PENSKE EXPANSION

SITE PLAN

LOT 1, BLOCK 1, PENSKE SUBDIVISION FILING NO. 2

OVERALL SITE PLAN

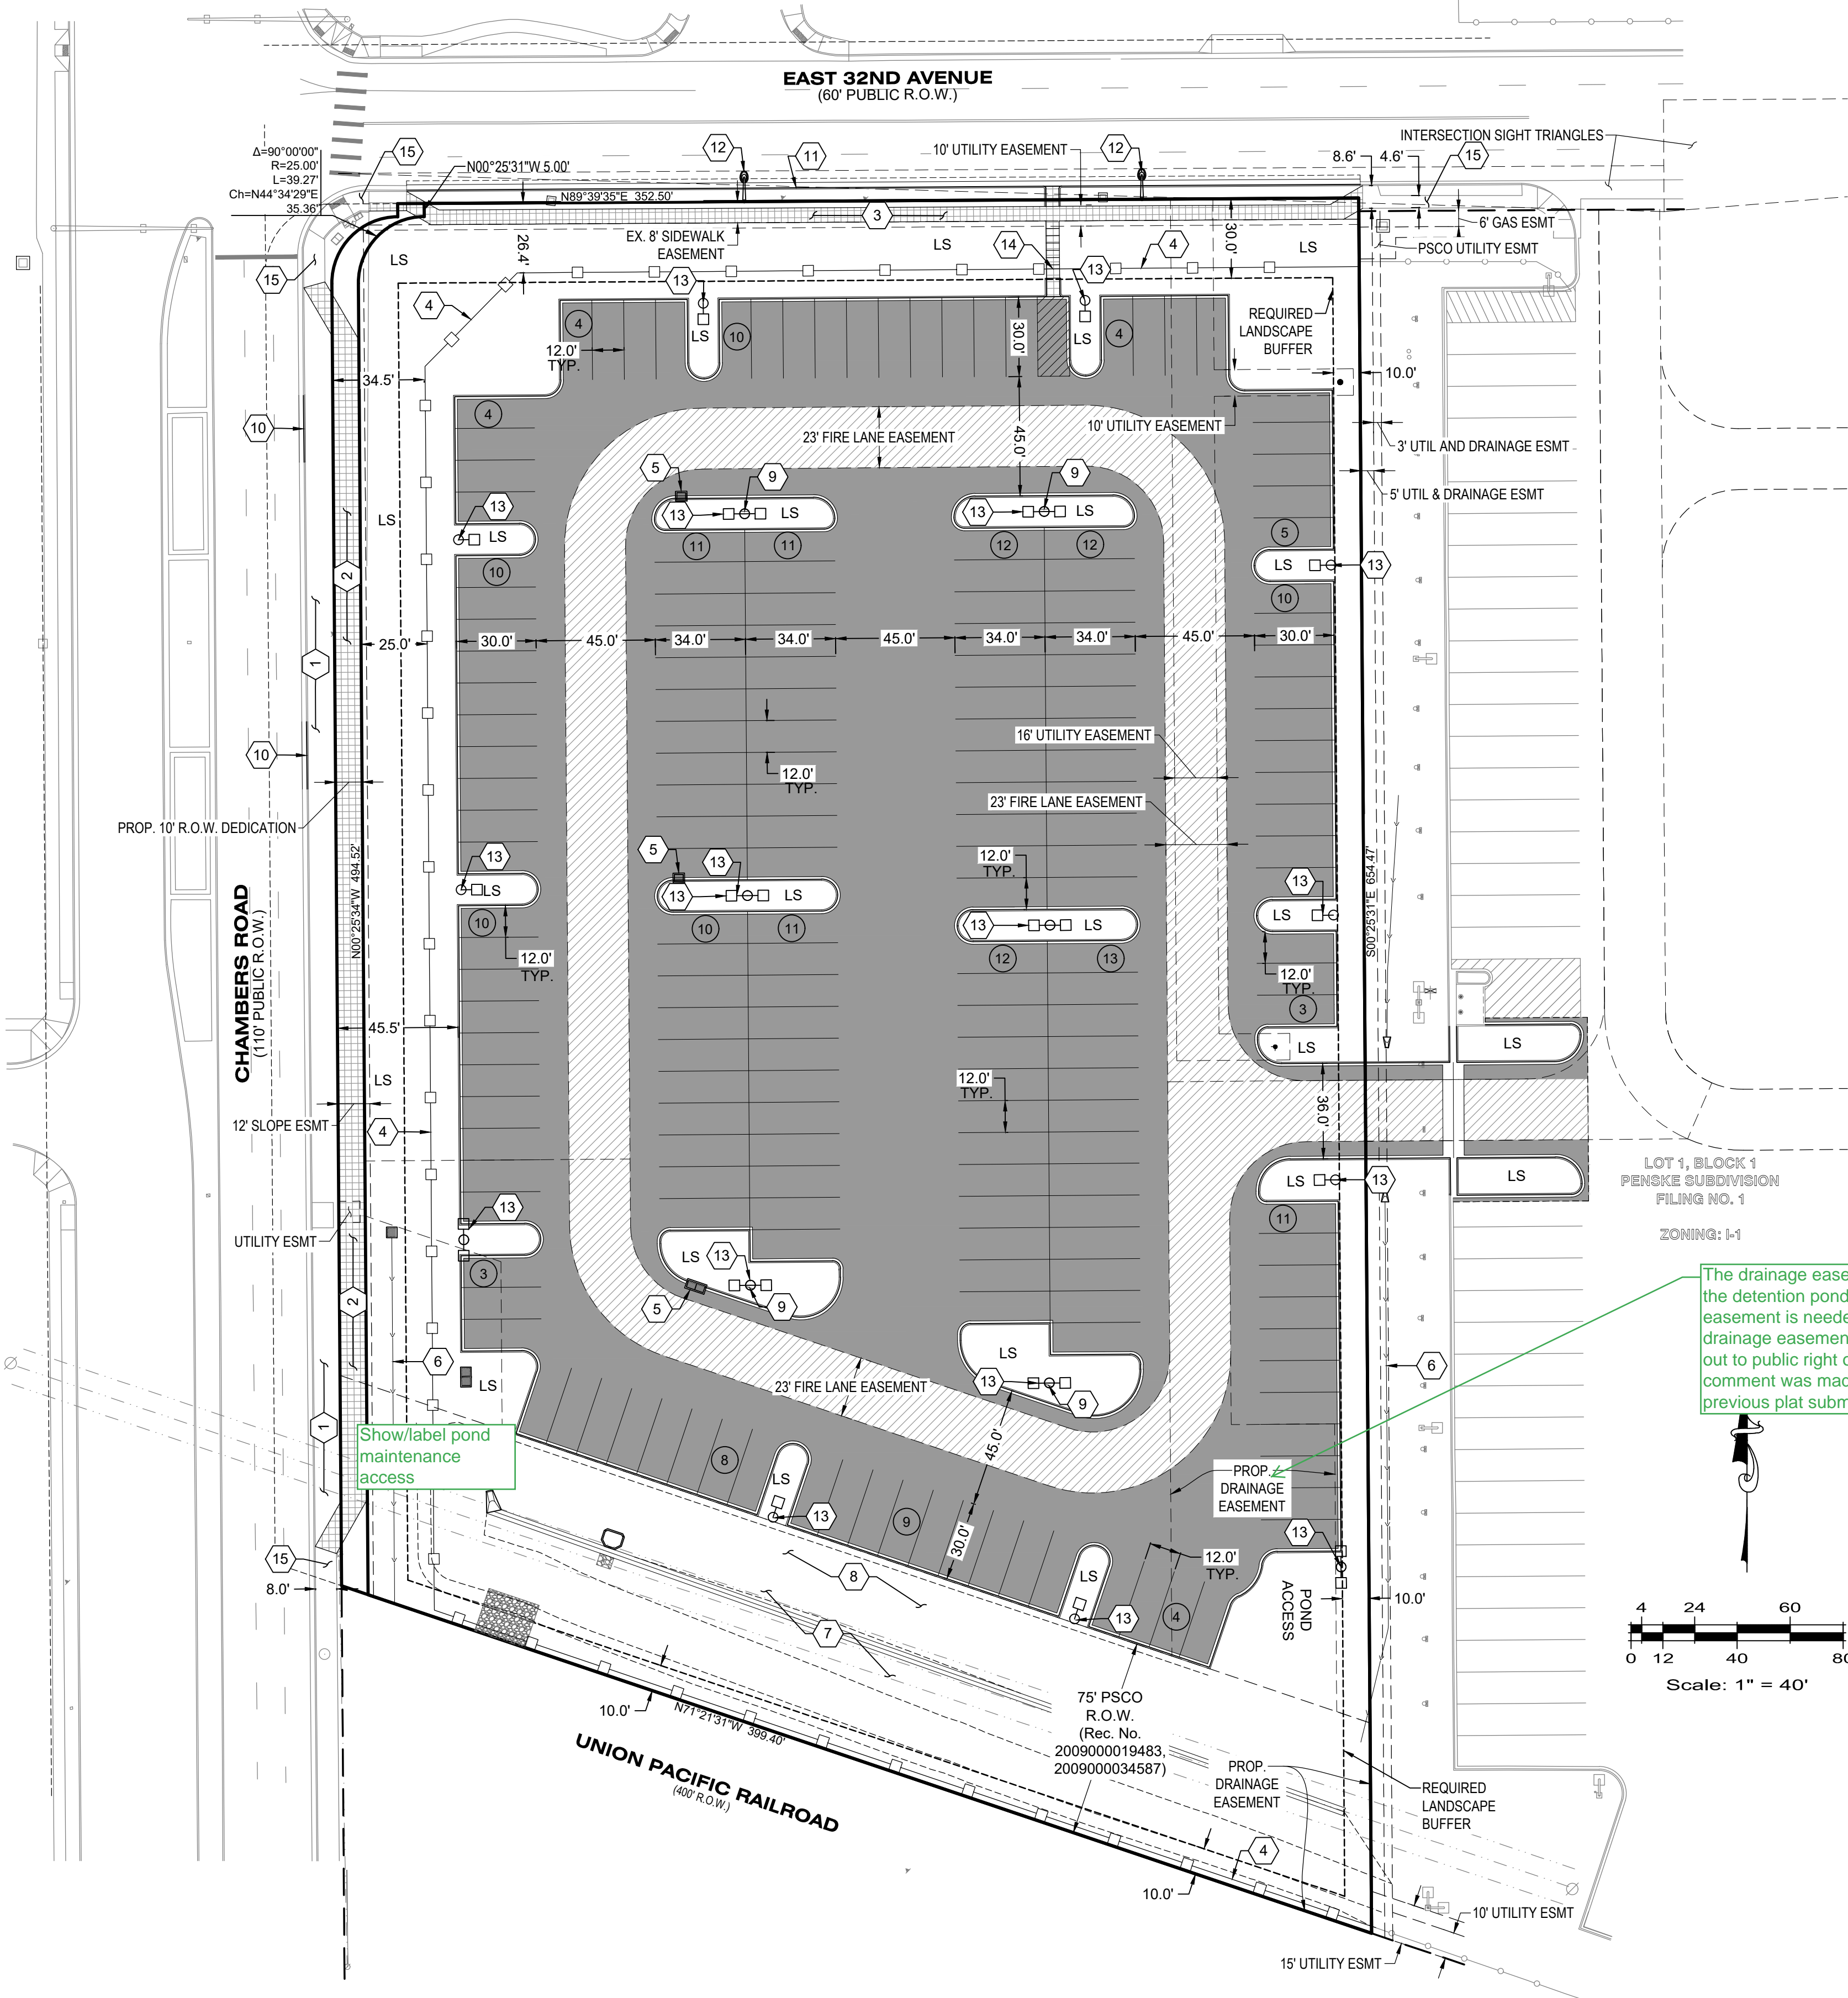
The drainage easement is only for the detention pond. An access easement is needed from the drainage easement for the pond out to public right of way. This comment was made on the previous plat submittal

GRADING AND UTILITY PLAN

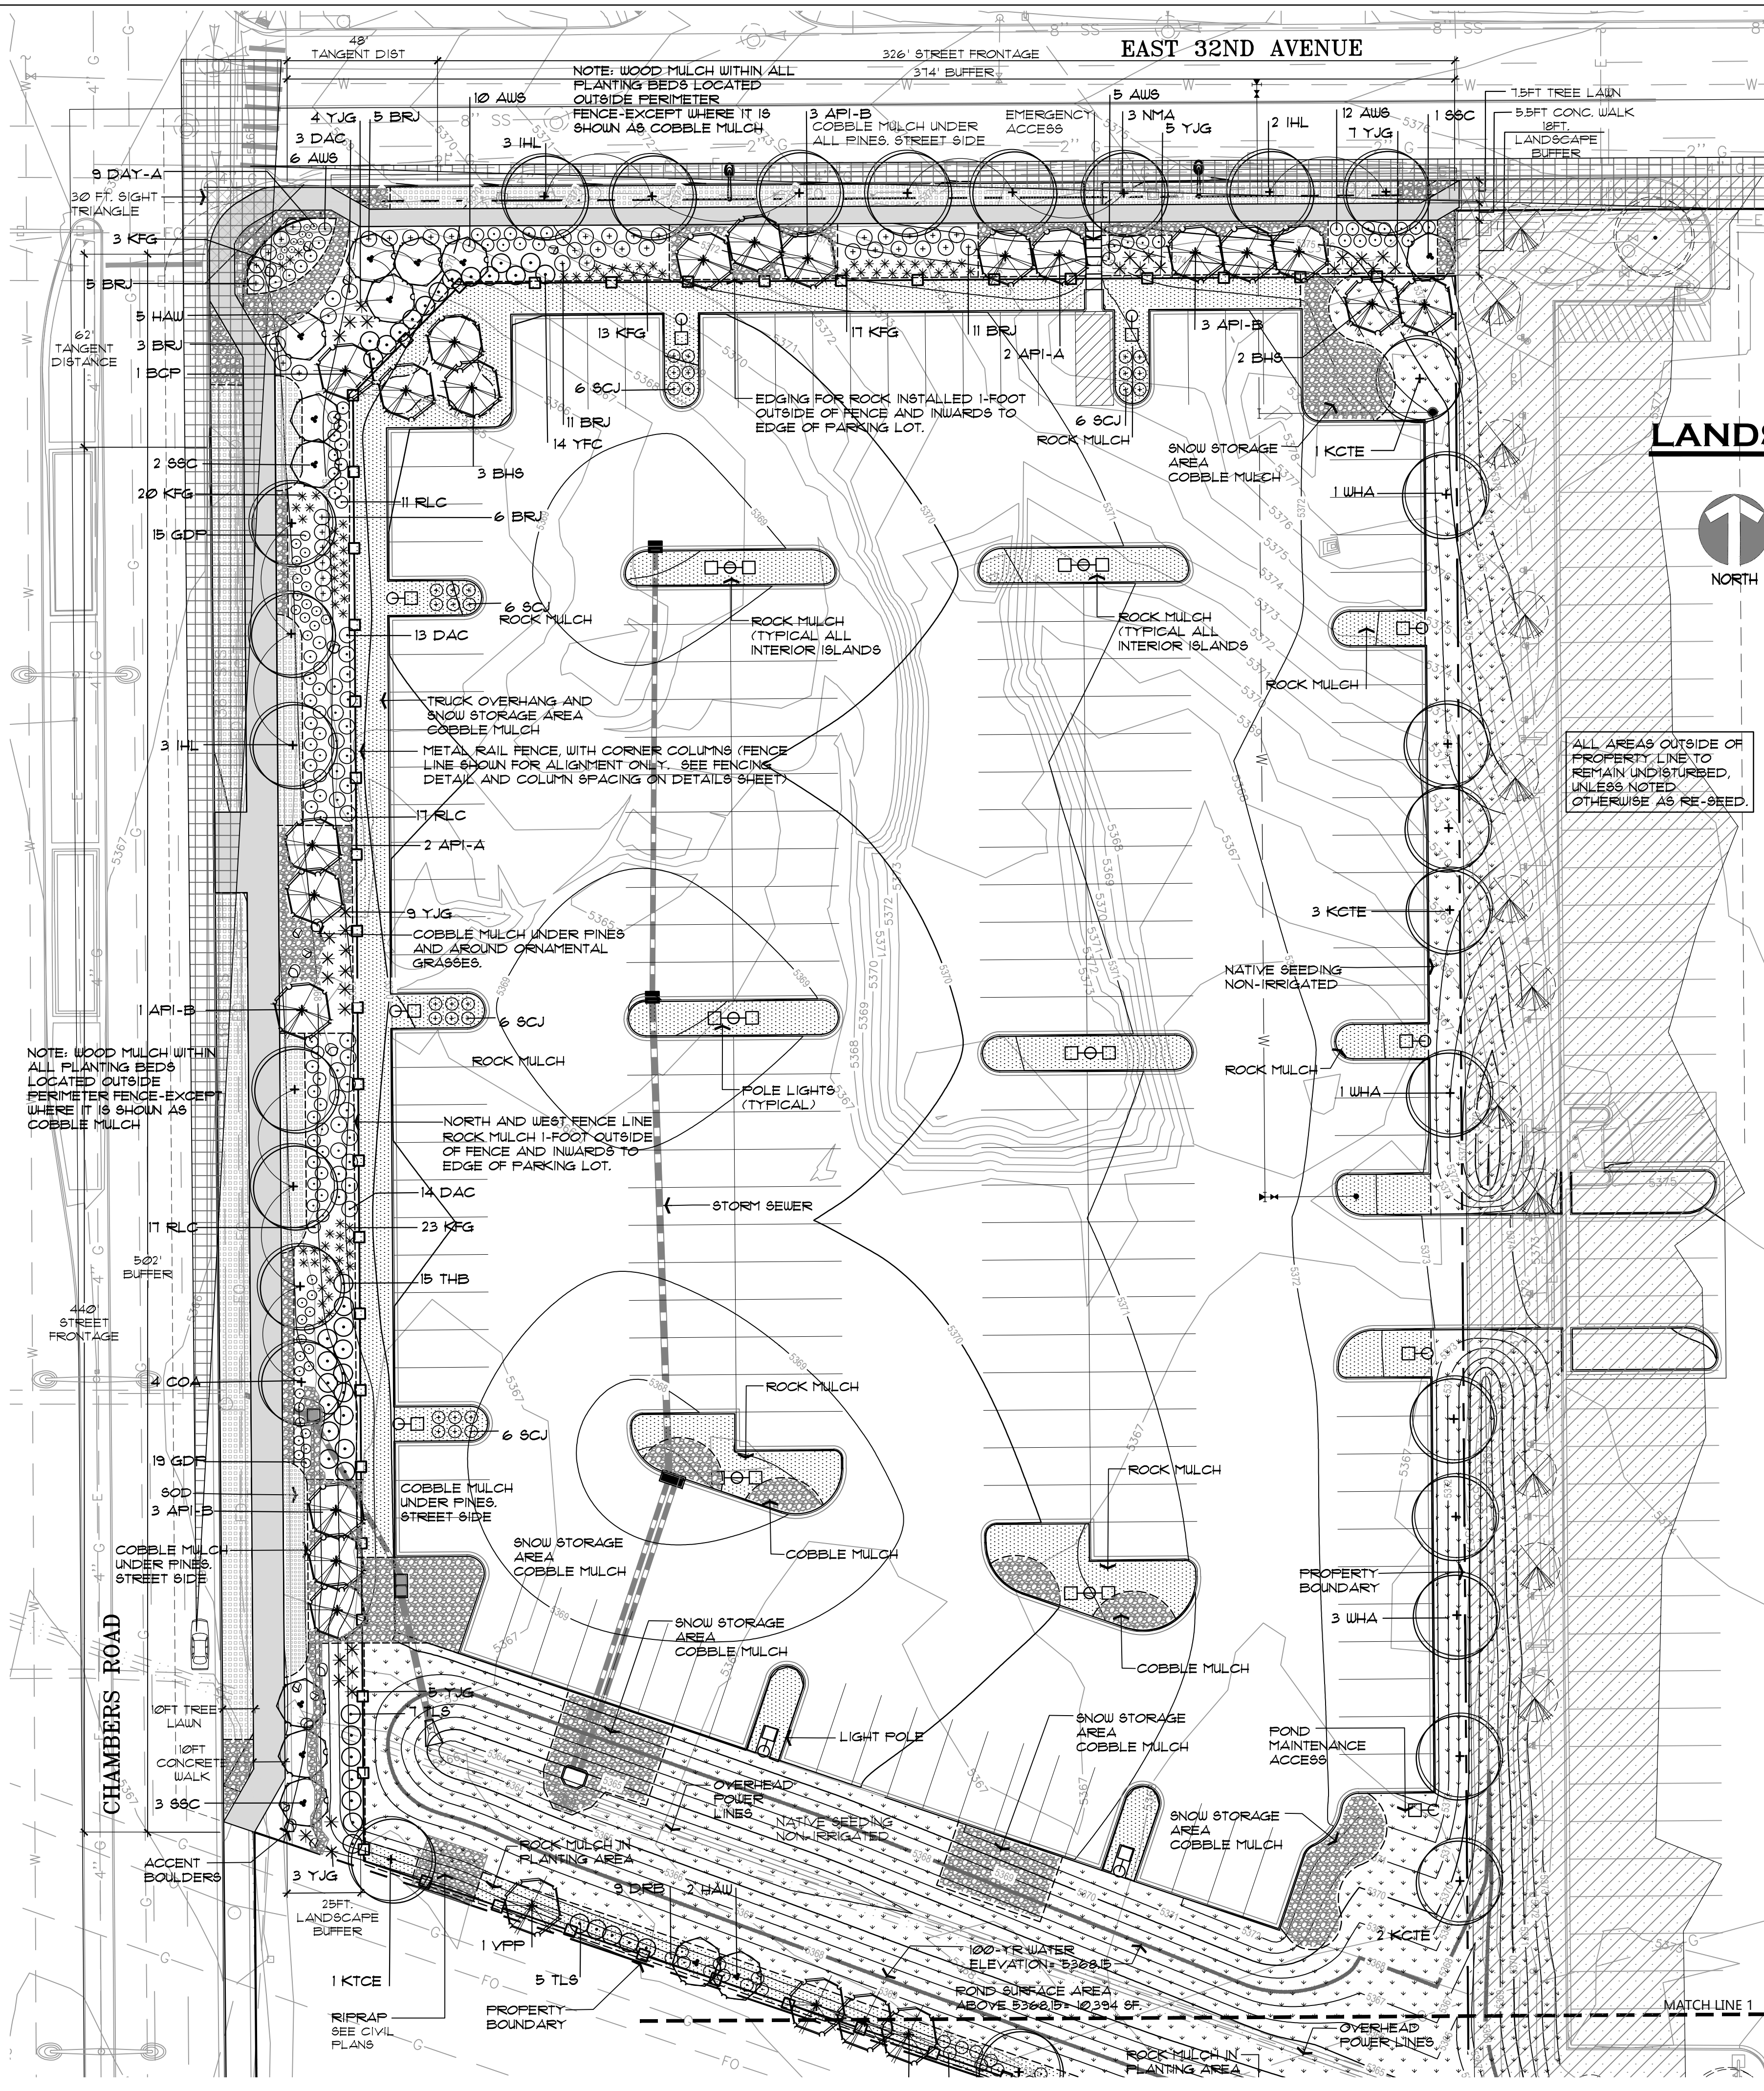
Street lights have this label

Note 12 calls out a 6 inch fire line. Please clarify.

Label maintenance access to bottom of pond. It was located in this area in the original pond design.

This area was labeled as pond access on the site plan. How is access provided?
